APPENDIX G: DESIGN INTEGRITY REPORT

**Pitt Street South Over Station
Development**

Issue for SSD DA Response to Submission Request for Information

SMCSWSPS-URB-OSS-PL-REP-000011

Loading Dock Access Option 1 (Revised from Base Scheme)

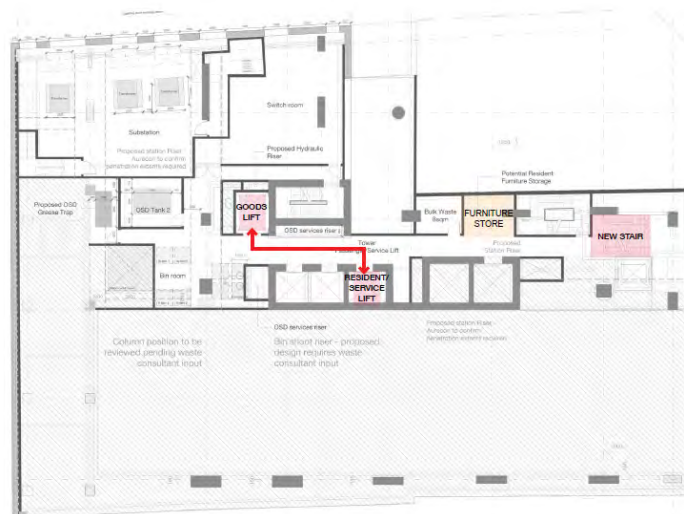
- The Panel supports the proposed lift numbers on the basis of the analysis presented – being 3 passenger and 1 service lift for 227 apartments.
- The Panel raised concerns about the level of service provided by the current arrangement of loading dock and service lift (that requires changing lift at the lobby level). The Panel requested to see alternative configurations bringing the residential service lift closer to the goods lift, or ideally a model that does not require lift change from loading to apartment floors, whilst noting that the client is confident that this model is workable.

- The Panel accepts the design change presented for loading and vertical transport which achieves direct access from the loading dock into a larger residential service lift at the entry level, avoiding the need to transfer between lifts at the upper level.

South facade: Part Elevation

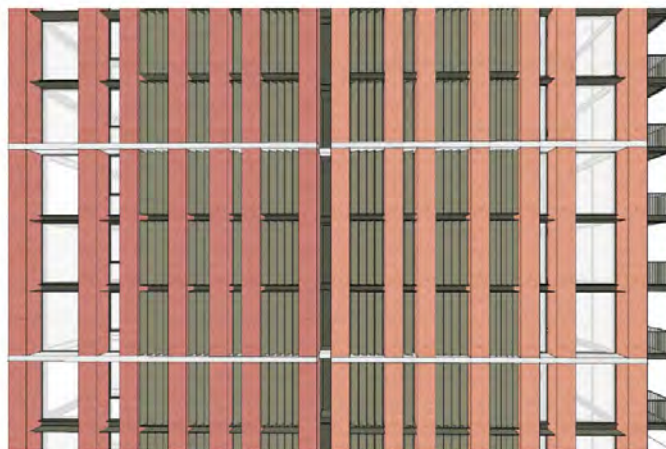
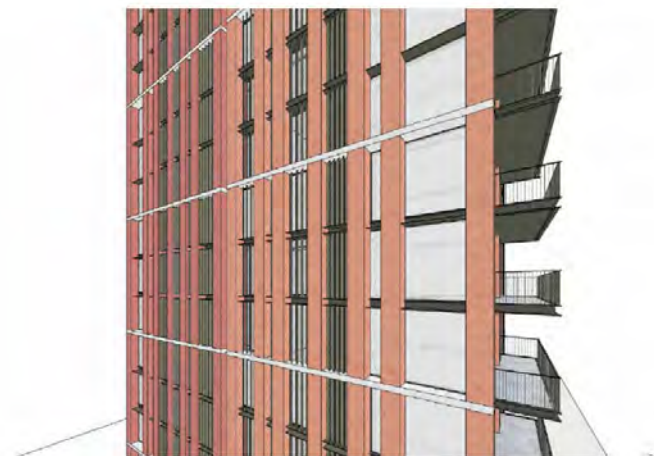
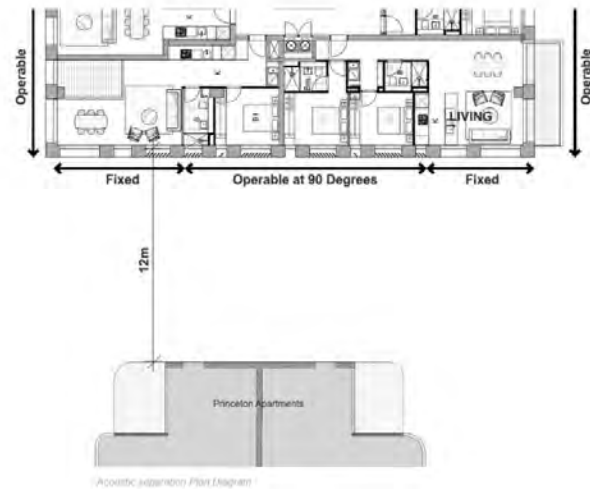
- a. *Demonstration that the loading dock and service lifts will provide a sufficient level of service.*
- b. *Interface with Princeton Apartments (southern facade) with the DRP requiring resolution in the following:*

1. *Visual privacy*
 2. *Acoustic privacy*
 3. *Natural ventilation*
- c. *Different treatment to the precast façade panels at street level in order to provide a richer sense of detail*

The Panel supports that visual privacy is achieved through the noted vertical louvres to the apartment windows facing the Princeton Apartments.

South façade ventilation

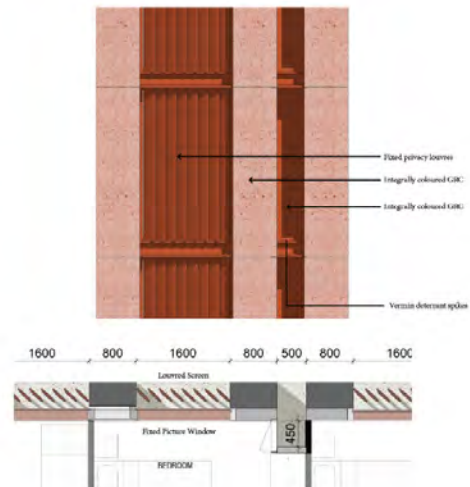
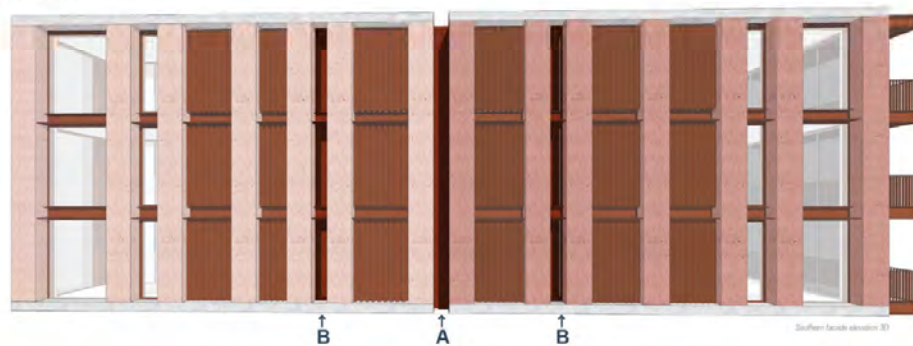
- Conflict between safety and cleaning
- Conflict between access to ventilation and acoustic separation

The **Option 2** ventilation strategy was endorsed by the DRP after referral to and consultation with the City of Sydney

- The Panel accepts removal of the vertical blade to the ventilation slot on the south façade (Princeton Apartment interface) noting further development of horizontal ledges to be provided.

Pitt Street Elevation Current and Option 2 and 3

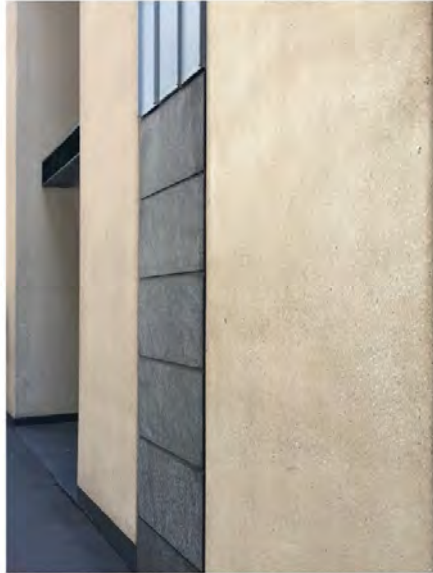
- The Panel recommends considering a different treatment to the precast façade panels at street level in order to provide a richer sense of detail.

- The Panel note that limited options were developed by the design team to introduce detail into the street level precast panels. The Panel acknowledge that mimicking the brick striations/banding is not a suitable response and recommend further investigation be undertaken to test texture and applied finishes to resolve a finer level of design detail, and that additional larger scale samples are developed and request the DRP are invited to review further proposals. (DIT Item 4.01 response)

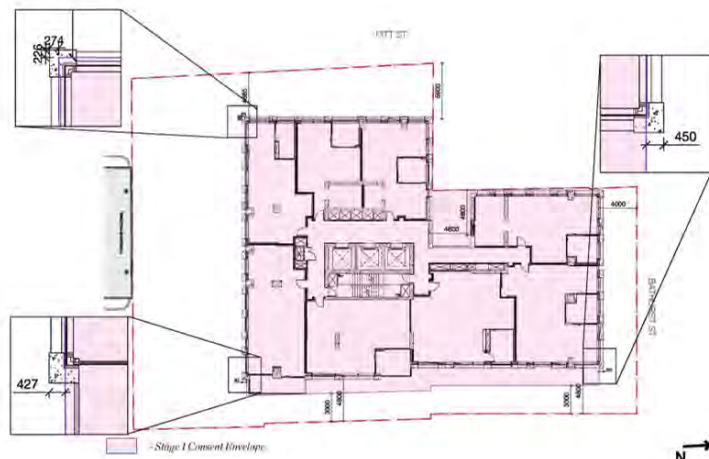
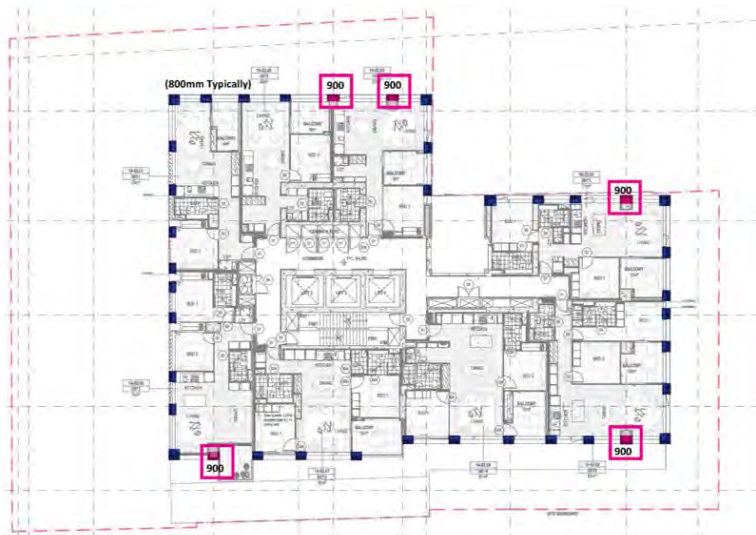
As context, from a DPIE perspective, the encroachments are sensitive in 3 ways

1. **South:** Building separation and privacy with Princeton
2. **West:** Solar impact (if any) on Princeton
3. **North:** Achievement of quality streetscape on Bathurst Street

- The adjacent drawing shows the current design. The majority of façade projections are 800mm wide x 400mm deep.
- Due to the presence of 4 perimeter columns, these 4 were required to adopt an atypical dimension and were 900mm wide x 400mm deep.
- This resulted in an inconsistency of façade widths we ultimately hoped to refine during detailed design, however the columns cannot decrease in width to achieve 800mm on these elements.

11.03 Depth to GRC Facade Elements

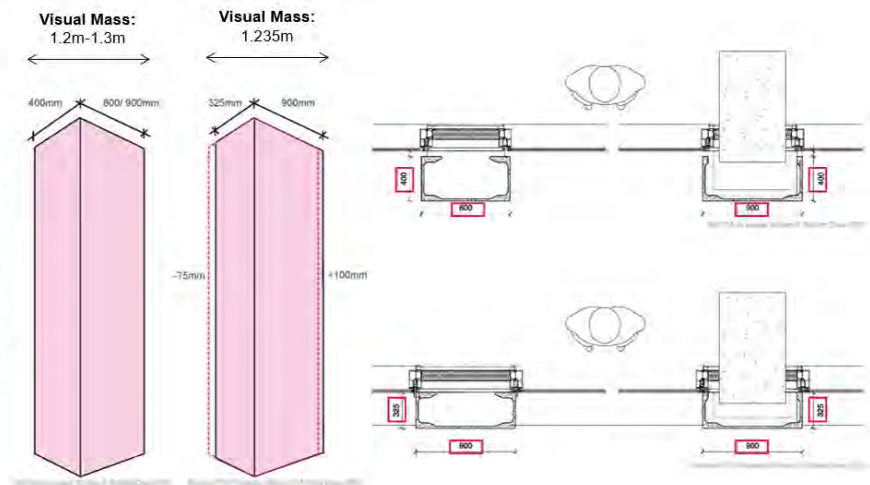
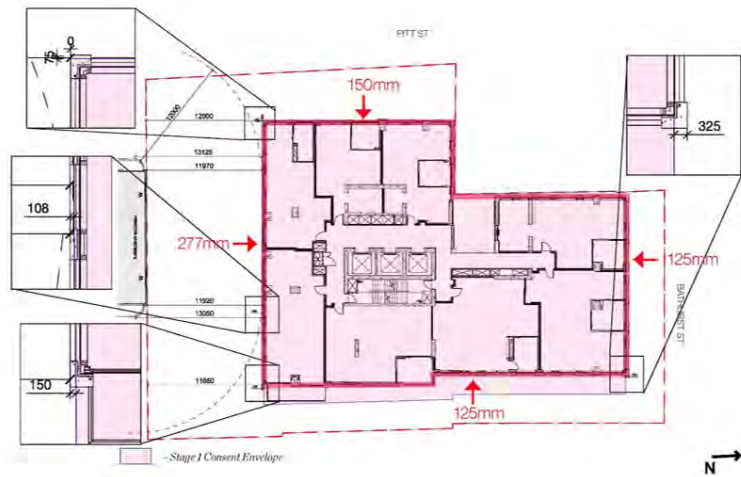
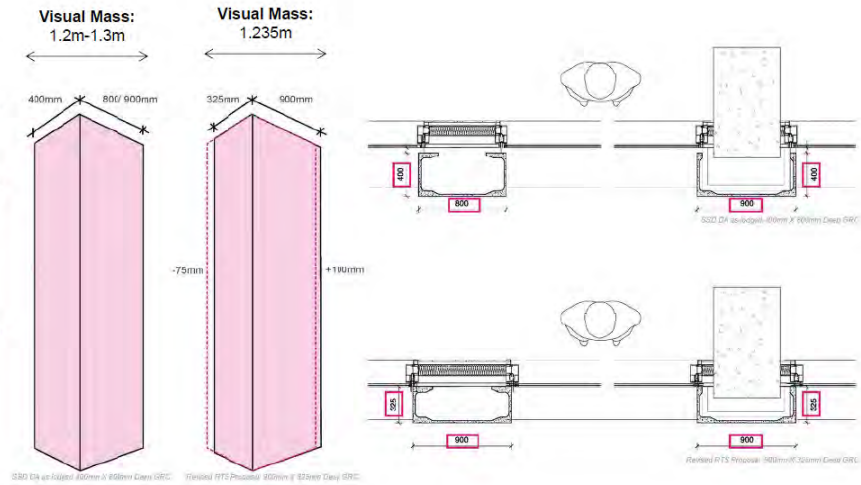
*Following the review of the 1:1 printed detail of the GRC façade elements, the Panel does not support the reduction in depth of the GRC unit. The Panel believes the flattening of these elements changes the architectural expression of depth and relief in the façade that the initial design proposed, and recommends the **original depth of 450mm to the glass line be maintained.***

*The Panel supports the change in **width of the GRC units to 900mm.***

- The revised standardized dimension of 325mm x 900mm now allows all façade elements to achieve a constant 'visual mass' of 1.235m, greater than that of almost all of the previous façade elements. Thus we:

- The revised standardized dimension of 325mm x 900mm now allows all façade elements to achieve a constant 'visual mass' of 1.235m, greater than that of almost all of the previous façade elements. Thus we:

11.01b Articulation of Pitt Street built forms to maximise solar access to living rooms of Princeton Apartments.

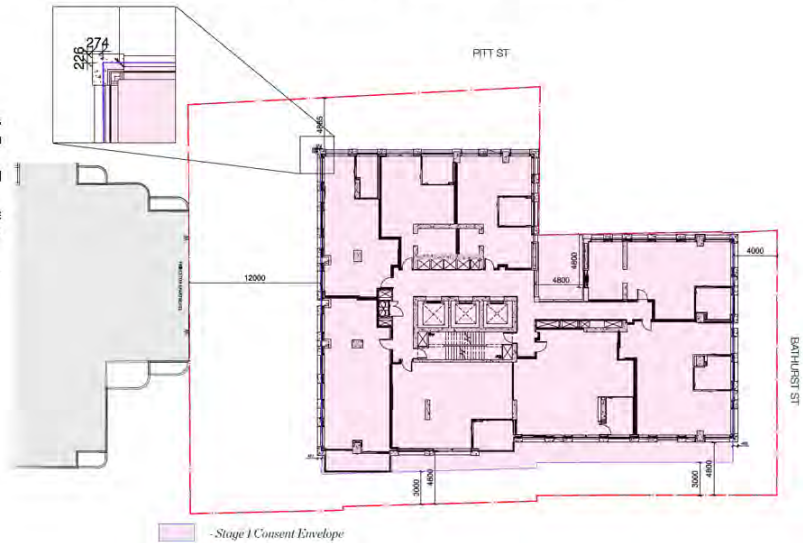
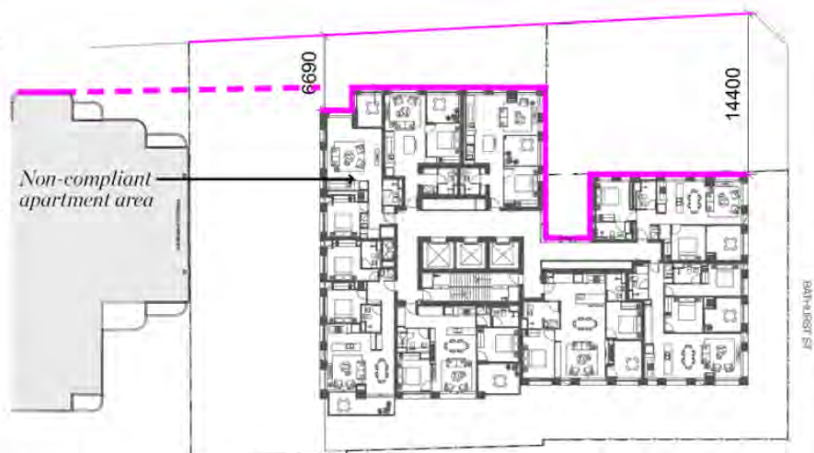
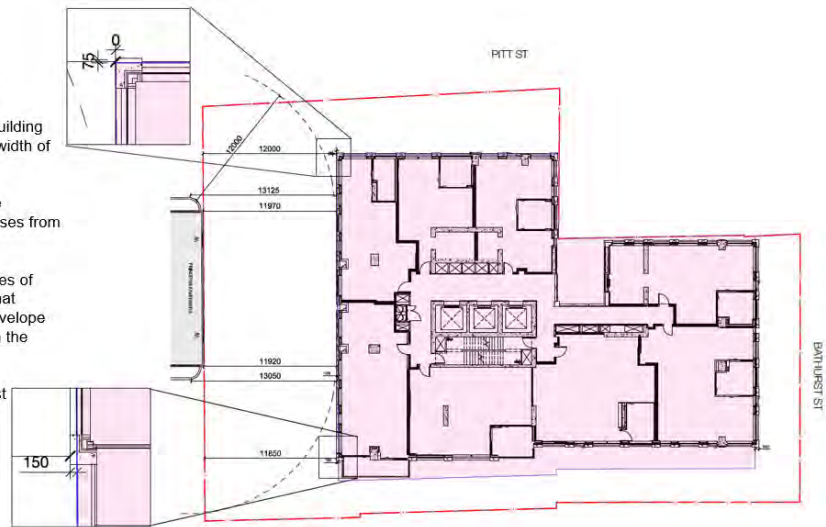
- As mentioned on the previous page, these non external non-habitable architectural shading elements project outside of the concept envelope by 226mm on the Pitt Street frontage for the portion between Princeton Apartments and the Edinburgh Castle Hotel
- The point at which these minor projections fall outside of the envelope on the South West corner results in 9 apartments within Princeton Apartments losing an average of 3 minutes of solar access between 9am – 3pm on the 21st June, when compared with the approved concept envelope.

- We have considered setting back the South Western corner by a further 2 metres as shown in the adjacent plan to improve solar access to Princeton Apartments.
- Our analysis shows that while doing so would result in 27 apartments in Princeton receiving a positive gain of 7 minutes of solar access between 9am – 3pm on 21st June, doing so would have the following detrimental impacts to the amenity of the proposed development:

- 20 apartments currently achieving 2 hours of solar access within the proposed development will fall substantially short of achieving 2 hours of solar access to either their living room or private open space, or both, during mid winter. This would reduce solar compliance of the proposed development from 50% to 42%.
- In addition, the same 20 apartments to those losing solar access, plus an additional 10 on levels 7 to 16, would also reduce in size below the ADG minimum 50sqm internal area required for 1 bedroom apartments.
- As such, the negative amenity impact to the proposed development is too significant in comparison to the very minor amenity benefit gained by Princeton Apartments.

- However, as described within Item 11.03 of this document, a reduction in the depth of the GRC projections is proposed on all four sides of the building and compensated for visually by an increase in width of these elements.
- Combined with a minor floorplate reductions, the resultant projection beyond the envelope decreases from 226mm to 75mm.
- This reduction is sufficient to restore the 3 minutes of solar access to Princeton Apartments to equal that offered under the approved Stage 1 Concept Envelope while also having no negative amenity impact on the proposal.
- This is therefore recommended as being the best amenity outcome for both buildings.

FACADE DETAIL

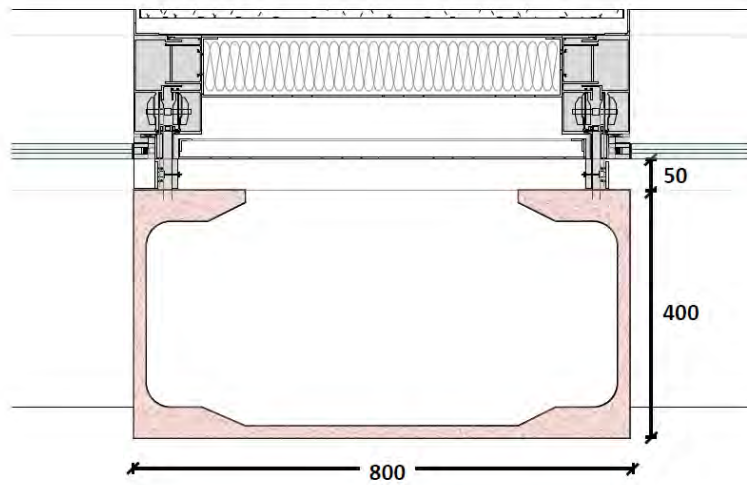
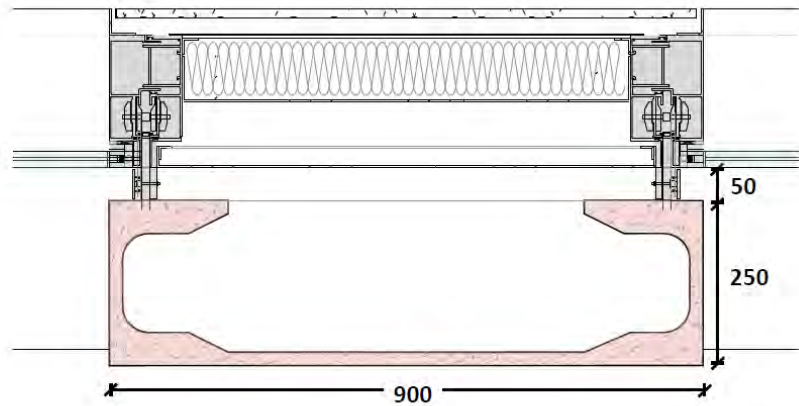
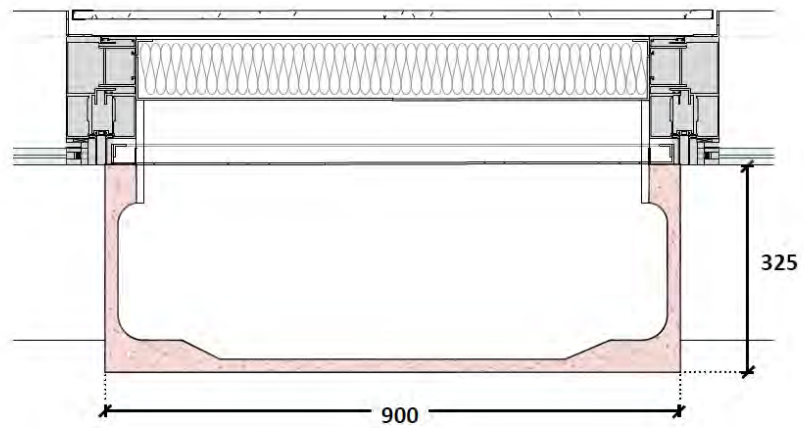
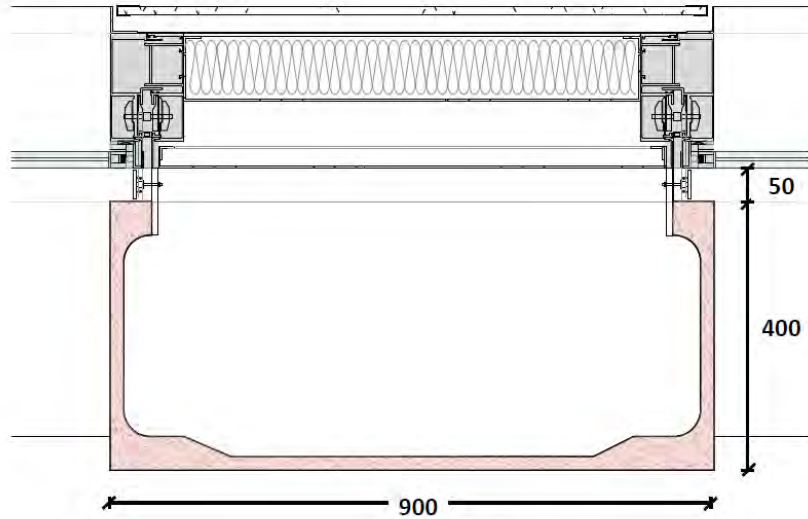
*The Panel notes that there has been a significant reduction in the quantity of GRC units in the façade from the initial Stage 2 DA to that which is currently proposed as part of the Response to Submissions. This reduction appears to have increased beyond that which was presented to the DRP on the 18th August. The reduction of quantity of solid elements on the façade is impacting design excellence – ie the **overall appearance** and integrity of the design, in addition to a potential increase in **solar load** on the building.*

/39 GRC elements
/900mm wide
/400mm deep
/50mm gap to facade
